# **KAK 13-033**

**The Collection LLC**

**Staff Report and Recommendations**

## **Modification #1 Increase of Podium Height**

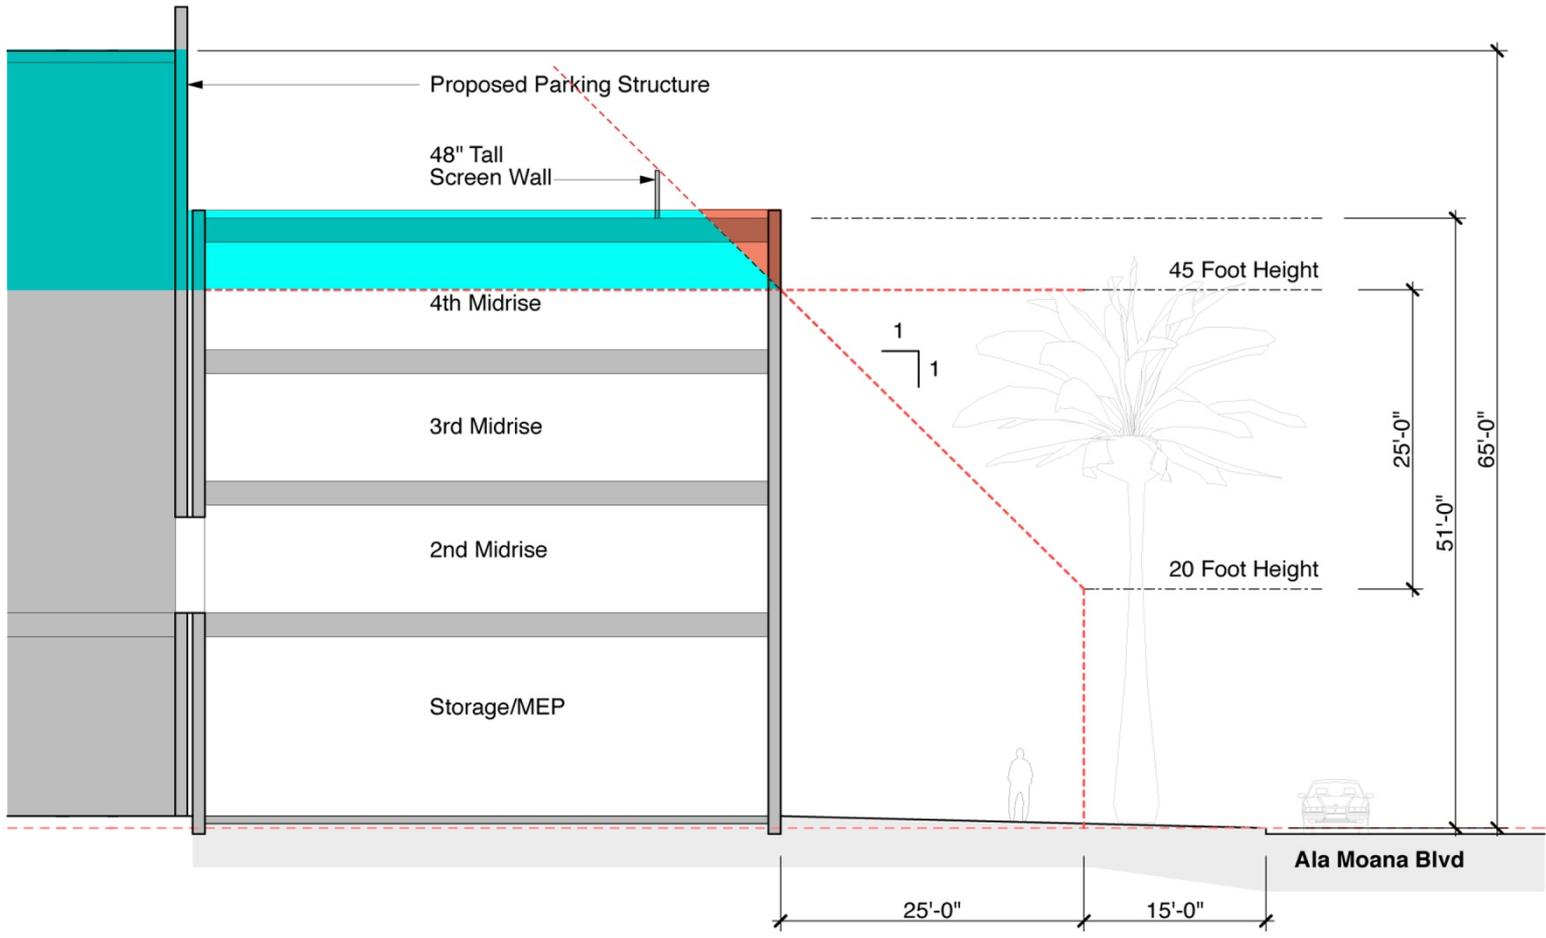
- **Subsurface Construction Will Encounter the Water Table at  $\approx$  6.7 feet**
- **Subsurface Construction Could Encounter Archaeological Material and is Potentially Damaging to the Environment**
- **Increasing the Podium Height Allows for Commercial Space at the Street Level & Above Ground Residential Units to Surround the Parking Structure**
- **The Increase in Podium Height Will Not Adversely Impact the Adjacent Ala Moana Boulevard**
- **Providing Commercial Space at the Street Level is a Practically & Aesthetically Superior Condition**
